Commonwealth Edison
One First National Plaza, Chicago, Illinois
Address Reply Post Office Box 767
Chicago, Illinois 60690

Subject: Dresden Station Units 2 and 3
Quad Cities Station Units 1 and 2
Containment Vent and Purge
Valve Operability
NRC Docket Nos. 50-237/249 and
254/265

ATTACHMENT 1

Response to Request for Additional Information
Quad Cities 1 & 2 and Dresden 2 & 3
Containment Purge/Vent Valves

FIGURE II.1

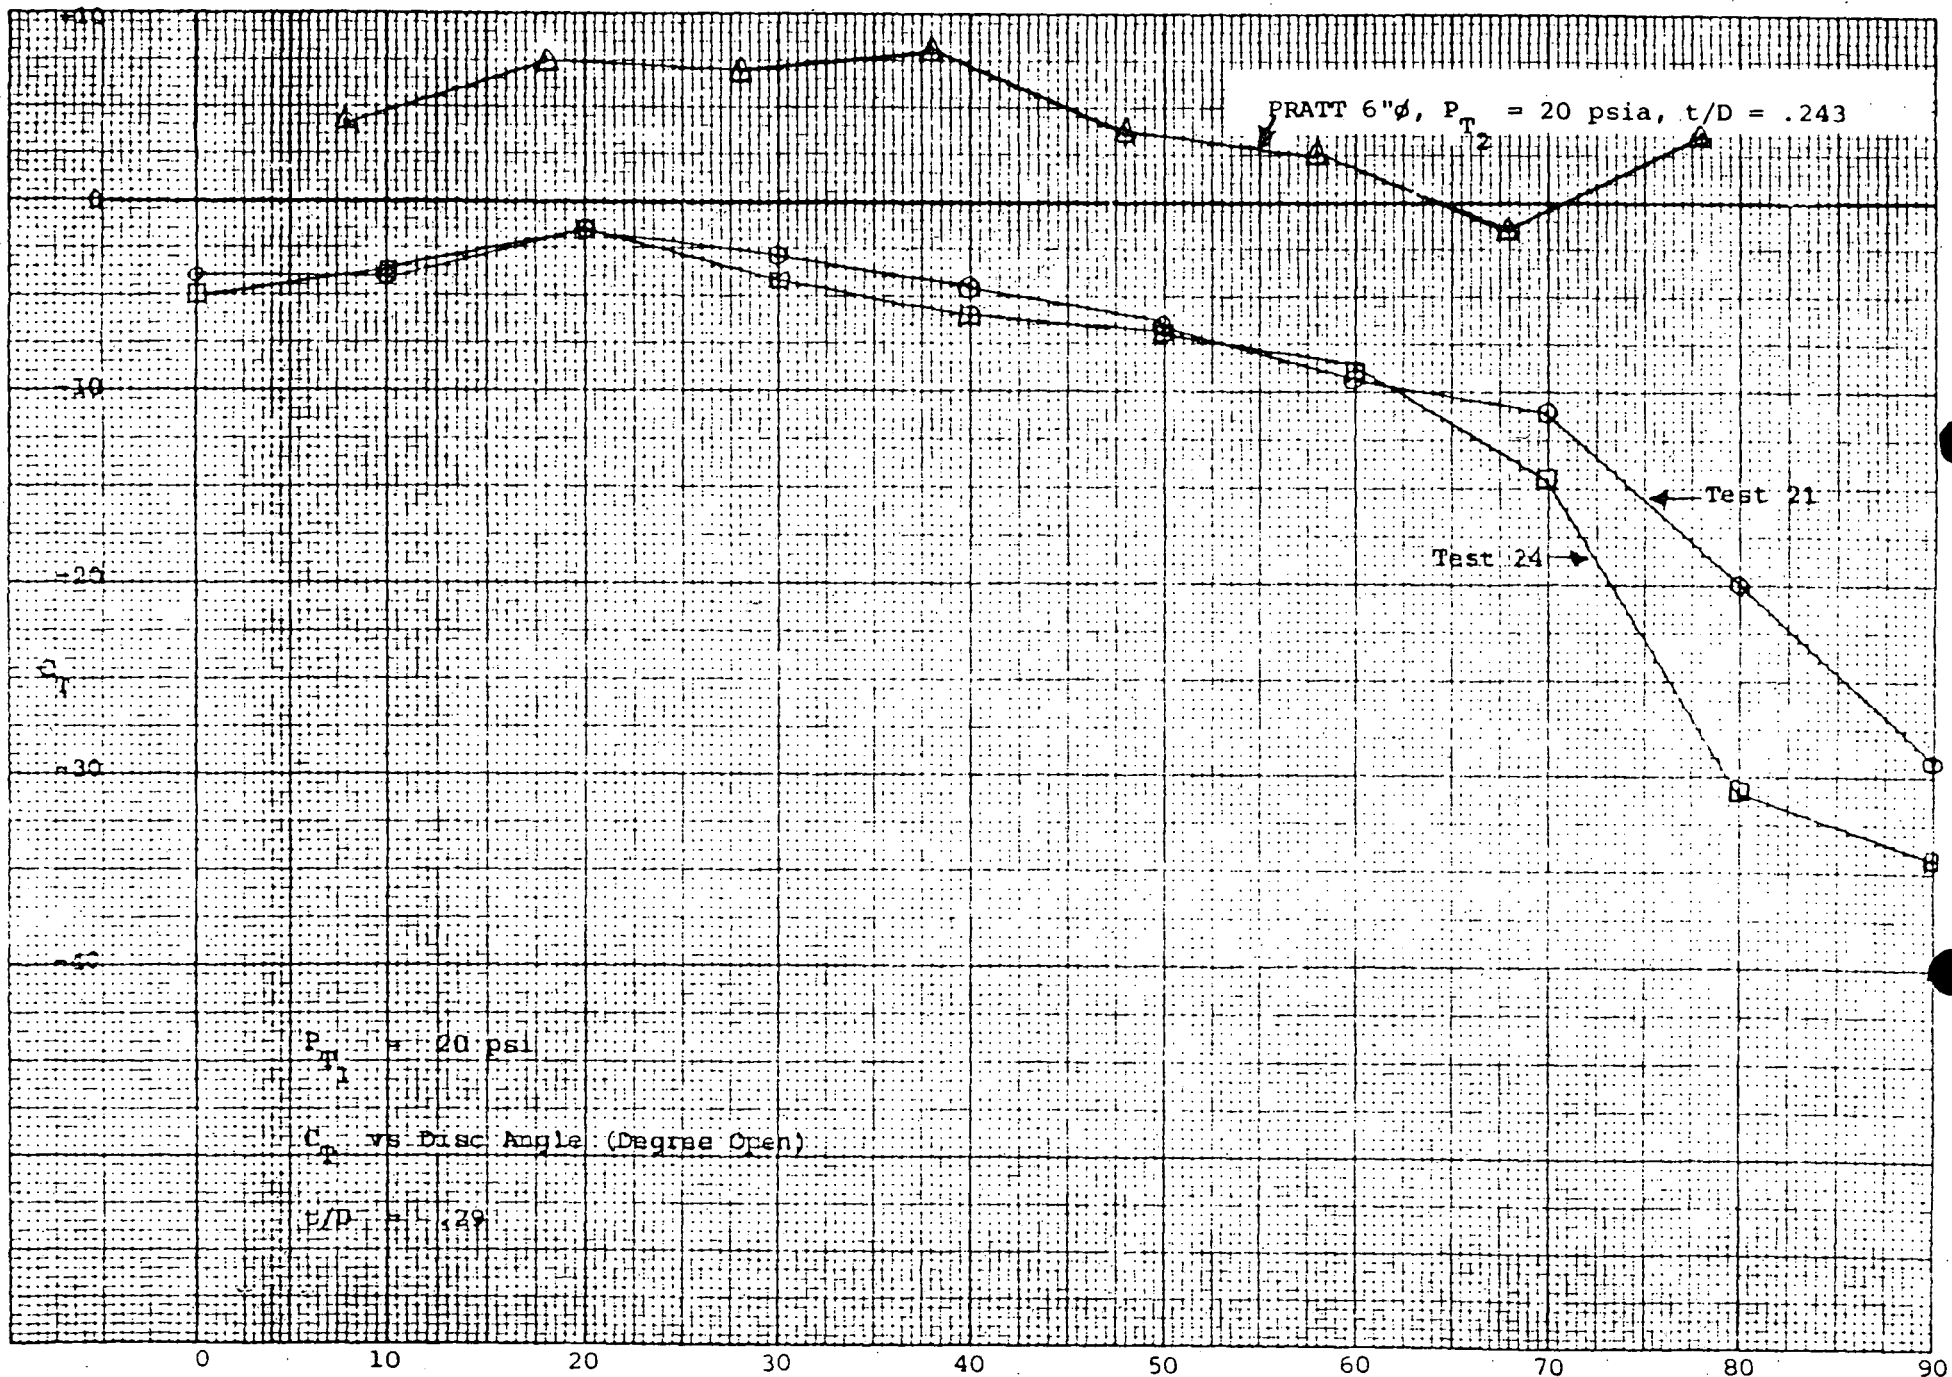
Question 1.1: Describe how each of the valve installations, relative to the piping configurations, have been reviewed to assure that the dynamic torque coefficients (C_T) developed by Fluid dynamic testing are applicable to the Dresden & Quad Cities valves. C_T can be affected by shaft orientation relative to close proximity of upstream elbows and disc closure direction relative to these close proximity upstream elbows.

The C_T information for Pratt valves in Tables II.1, II.2, and II.3 and tables extracted from the Allis-Chalmers report have been summarized in Figures II.1, II.2 and II.3. These figures show that the shape of the "in-plane" C_T curves are similar and that the maximum difference between C_T "in-plane" and C_T "out-of-plane" for sonic conditions ($P_{T1} = 40$ or 60 psia) for Allis-Chalmers STREAMSEAL valves is a factor of 1.283.

The maximum torque on a Pratt eighteen (18) inch butterfly valve, as scaled from test data gathered at Fluidyne, is 216 ft-lbs. Multiplying 216 ft-lbs times 1.283 yields a maximum torque value of 277 ft-lbs for "out-of-plane" valves. Since this is less than the 300 ft-lbs used in the valve analysis (Reference 1), no further evaluation is necessary.
